addendum no. three

OWASSO PUBLIC SCHOOLS
Owasso 8th Grade Addition

Architect: The Stacy Group
Project Number: 2407

03.26.2026

11 ROOF PLAN
SCALE:NTS

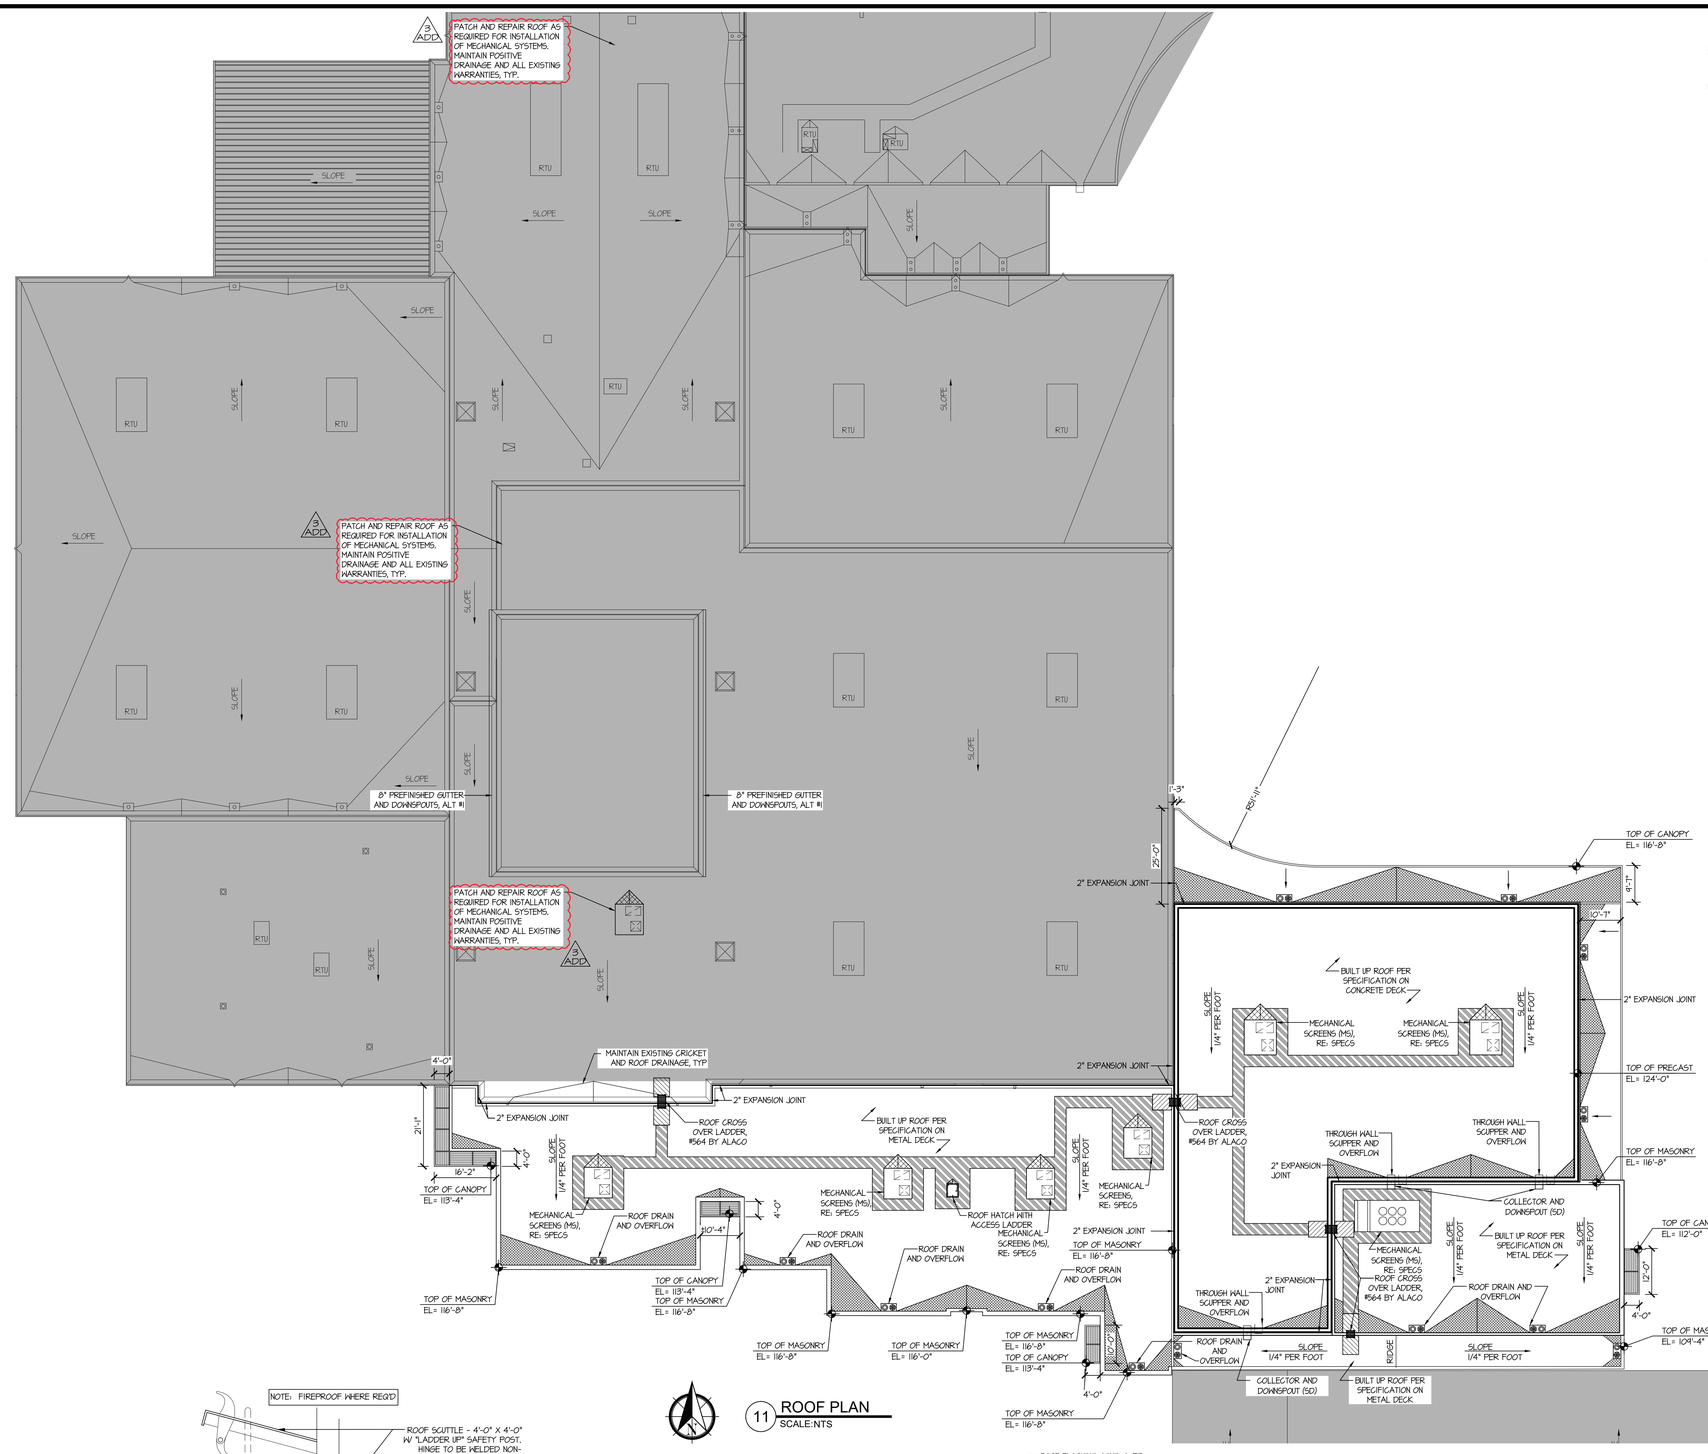
A3-25 Sheet A150 Roof Plan: Add notes for work on existing roof. Replace sheet in its entirety.

14 CEILING DETAIL
SCALE:1 1/2" = 1'-0"

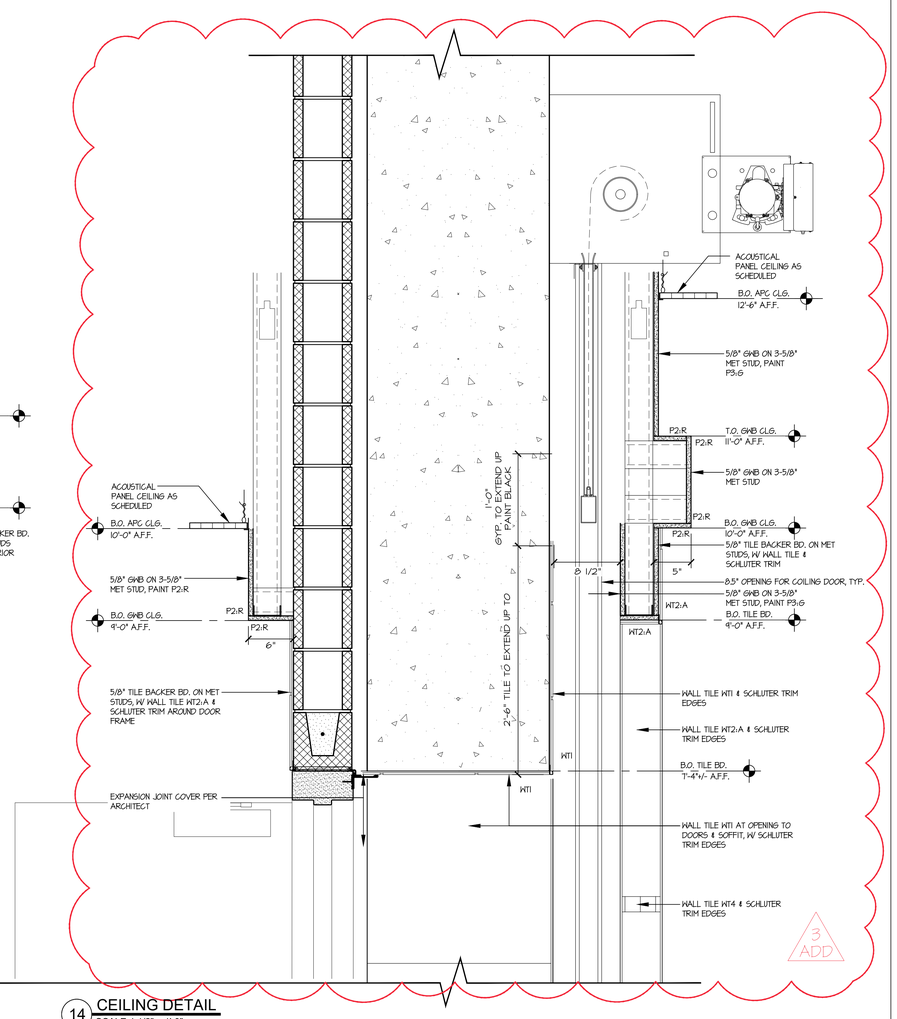
A3-27 Sheet A310 Ceiling Details: Revised Detail 14/A310. Replace sheet in its entirety.

16 WALL SECTION
SCALE: 1/2" = 1'-0"

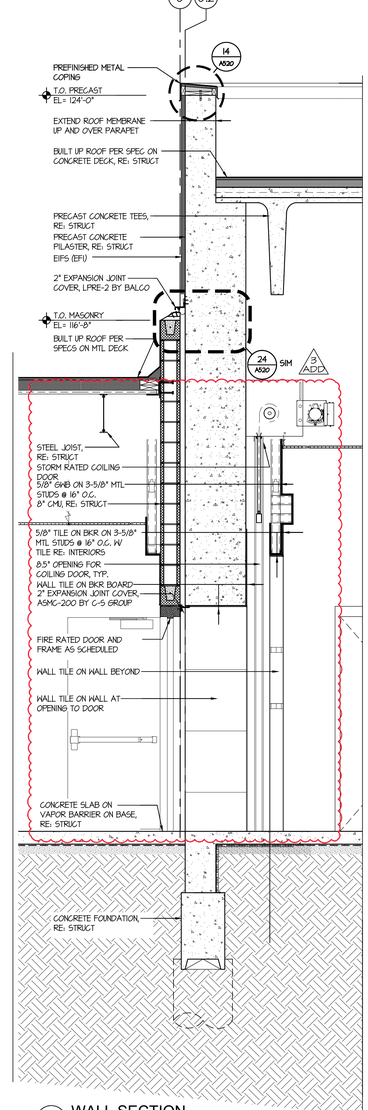
A3-28 Sheet A510 Wall Sections: Revise detail 16. Replace sheet in its entirety.

FLOOR PATTERN PLAN - AREA 1 - BASE BID
SCALE: 1/8" = 1'-0"

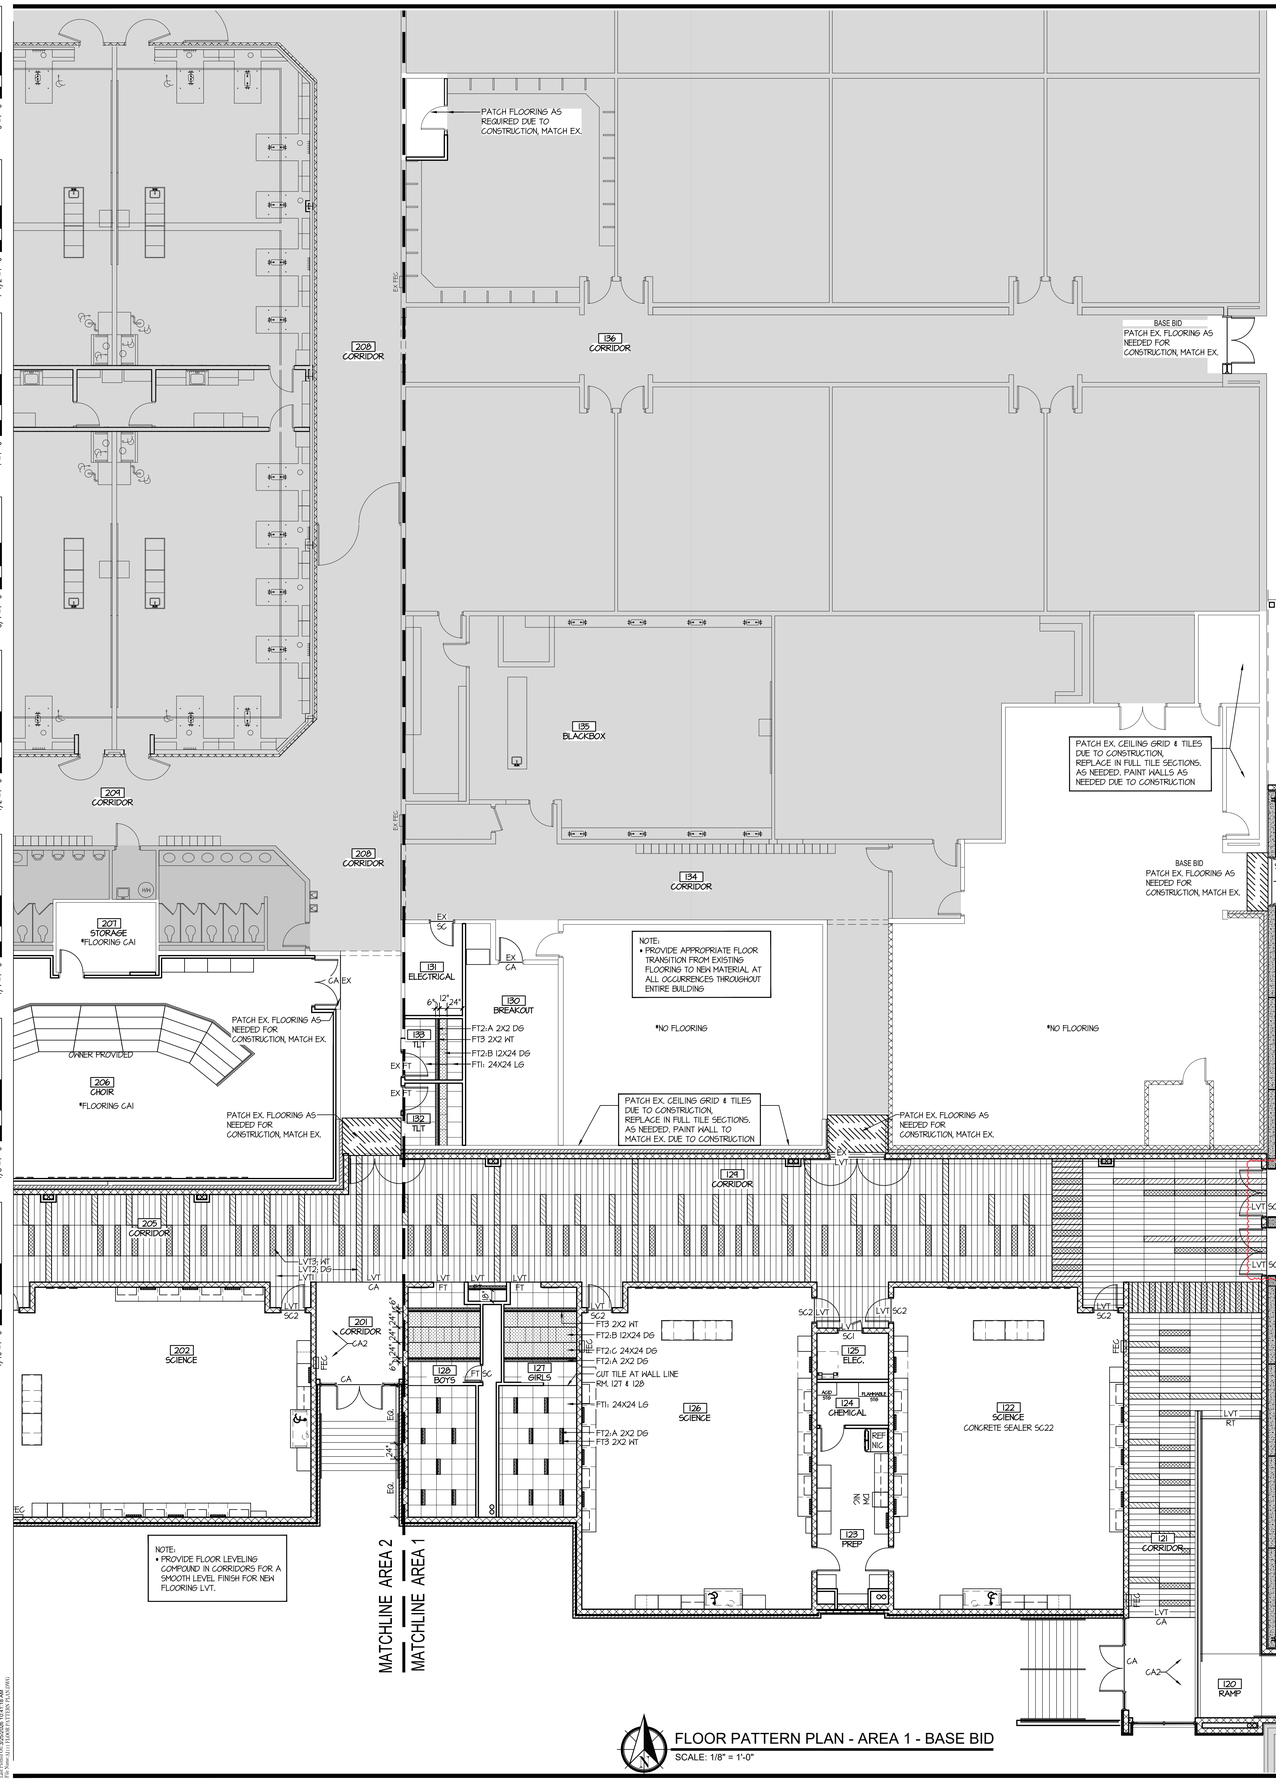
A3-32 Sheet AI111 Floor Pattern Plan Area 1 Base Bid: Revised floor finish locations at doors. Replace sheet in its entirety.

1 OVERALL FIRE PLAN
3/64" = 1'-0"

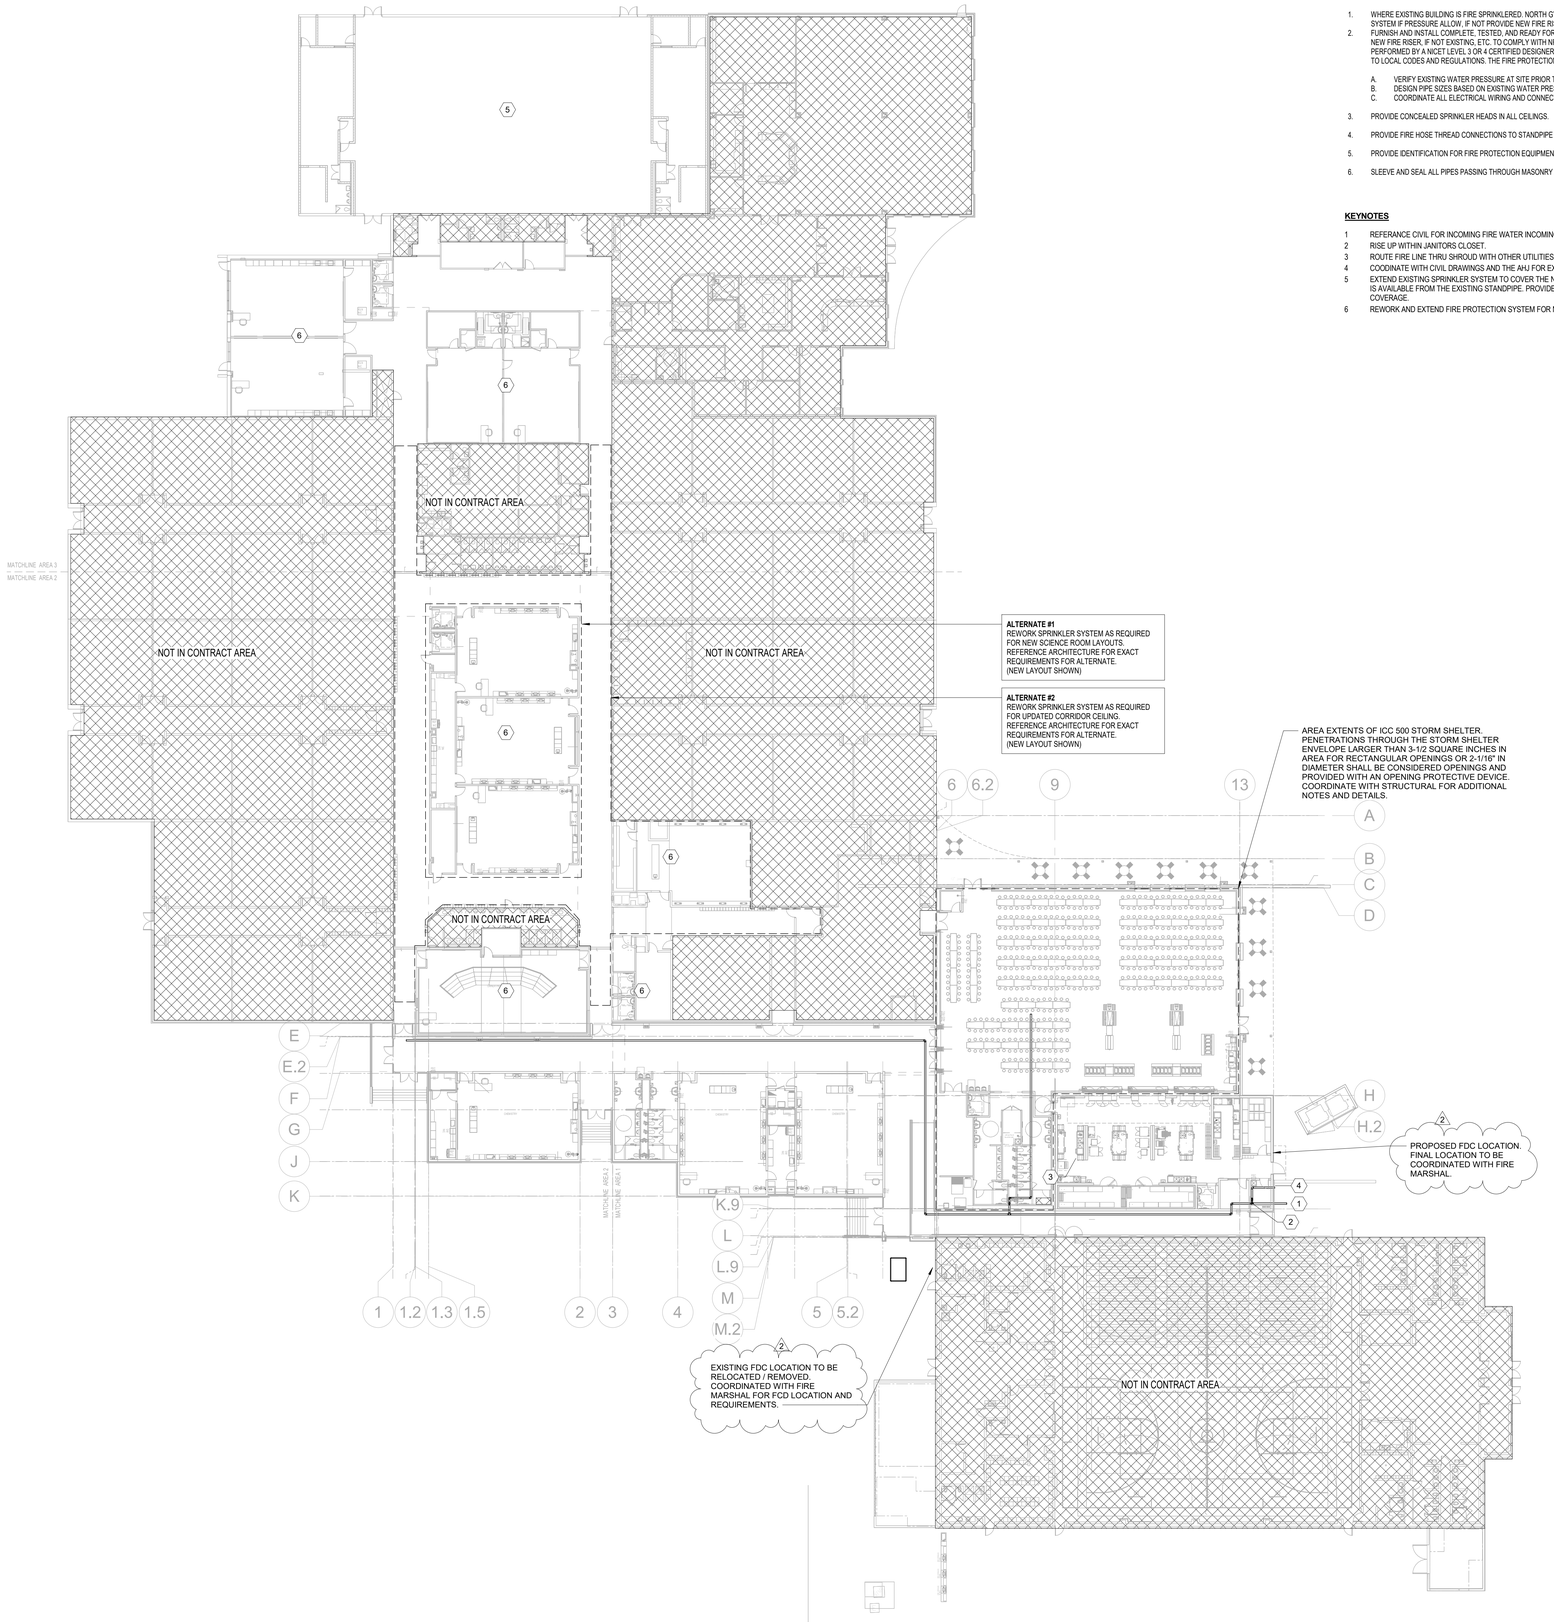
A3-41 Sheet FP100 Fire Protection Plan: FDC notes have been added per fire Marshall requirements.

1 LIGHTING PLAN - AREA 3
SCALE : 1/8" = 1'-0"

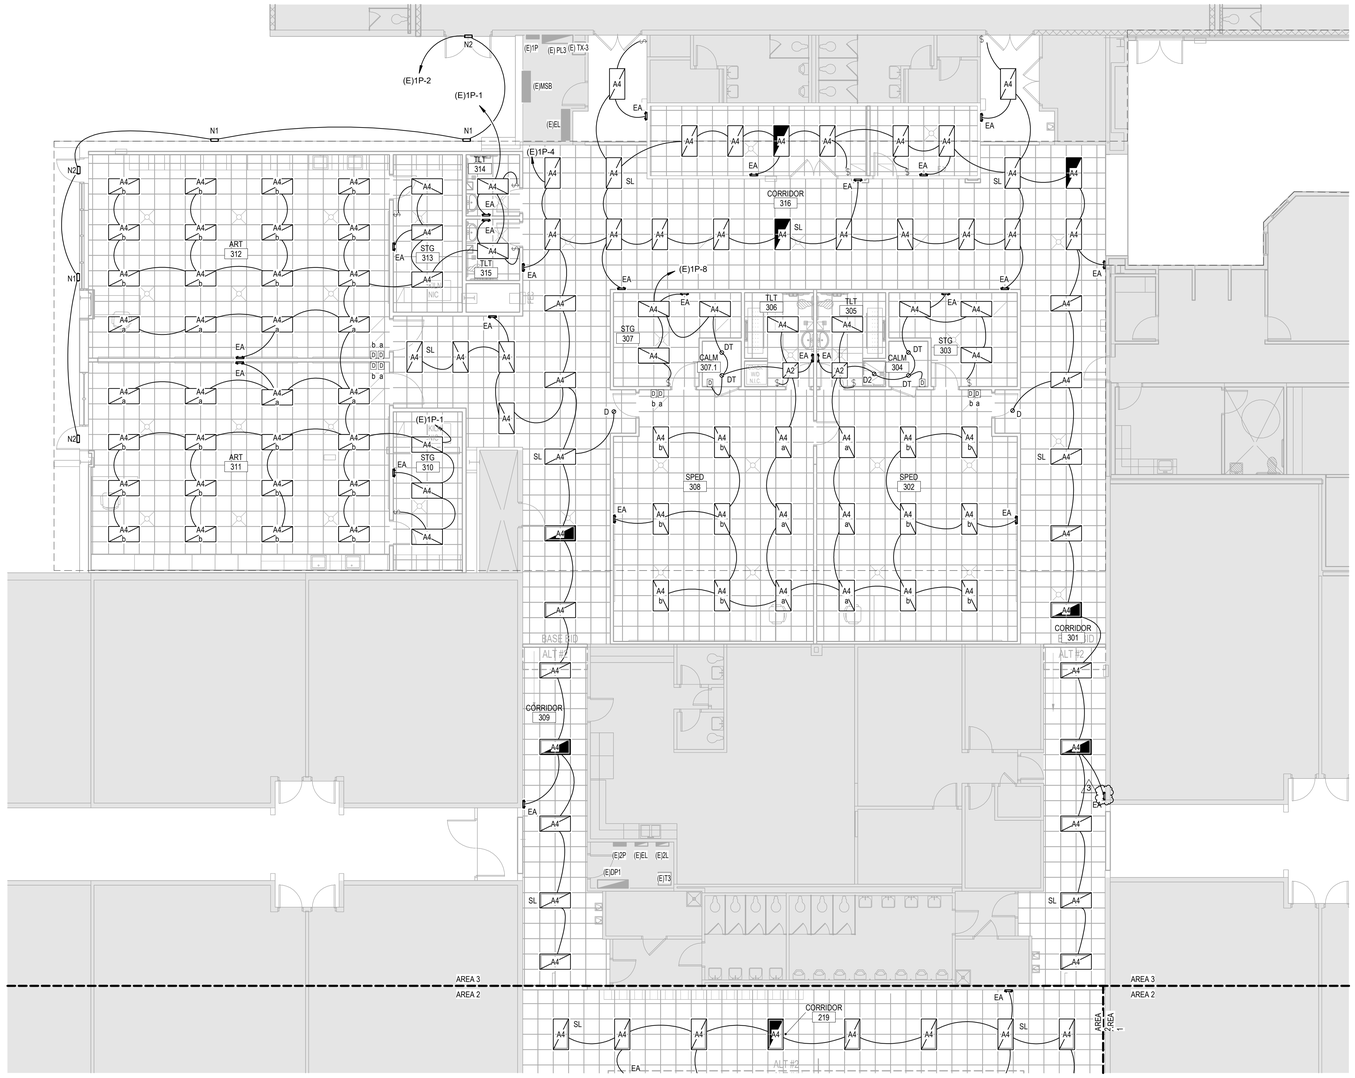
A3-45 Sheet E103 Lighting Plan – Area 3: Added emergency light to Corridor 301.
